# Access Compliance Report

### (Curb Ramps)

Intersection ID: 24566	Main Street: BARDSTOWN_RD	Cross Street: SPRINGS_FARM_LN	Location:	N
ADA ID: C71602BF2D91	Ramp Type: PerpDiag	Initial Pass/Fail: Fail	Overall Compliance: No	Severity Score: 25

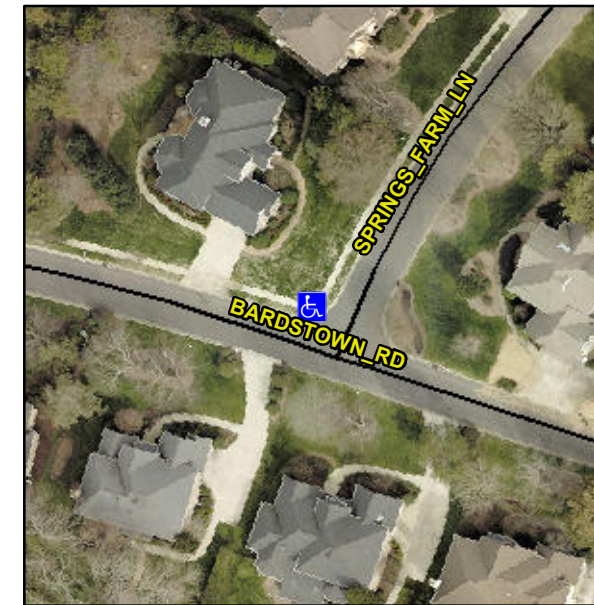
**Not Found, R304.5.3**

Compliance	Description	Data	Compliance	Description	Data
N/A	Ramp Length (in)	95.0	Yes	Ramp Slope (%)	5.8
Yes	Ramp Width (in)	48.0	No	Ramp XSlope (%)	8.6
N/A	Flare Type LT	N/A	N/A	Flare Type RT	N/A
N/A	Flare Slope LT (%)	N/A	N/A	Flare Slope RT (%)	N/A
N/A	Flare Traversable LT?	N/A	N/A	Flare Traversable RT?	N/A
N/A	Landing Length (in)	N/A	N/A	DWS Provided?	N/A
N/A	Landing Width (in)	N/A	N/A	DWS Contrast?	N/A
N/A	Landing Slope (%)	N/A	N/A	DWS Length (in)	N/A
N/A	Landing X Slope (%)	N/A	N/A	DWS Full Width?	N/A
N/A	Landing Curb? (Y/N)	N/A	N/A	DWS Offset (in)	N/A
N/A	Shared Landing?	N/A			
N/A	Gutter Ponding?	N/A	N/A	Gutter Slope (%)	N/A
N/A	Gutter Lip Ht (in)	N/A	N/A	Gutter X Slope (%)	N/A
N/A	Painted X Walk1?	No	N/A	Painted X Walk2?	No
	X Walk 1 Direction	To S		X Walk 2 Direction	To SE
N/A	X Walk 1 Width (in)	N/A	N/A	X Walk 2 Width (in)	N/A
	X Walk 1 Slope (%)	1.5		X Walk 2 Slope (%)	4.7
	X Walk 1 X Slope (%)	5.0		X Walk 2 X Slope (%)	0.1

**Remove & Replace Curb Ramp With Two New Directional Ramps or Equivalent.**
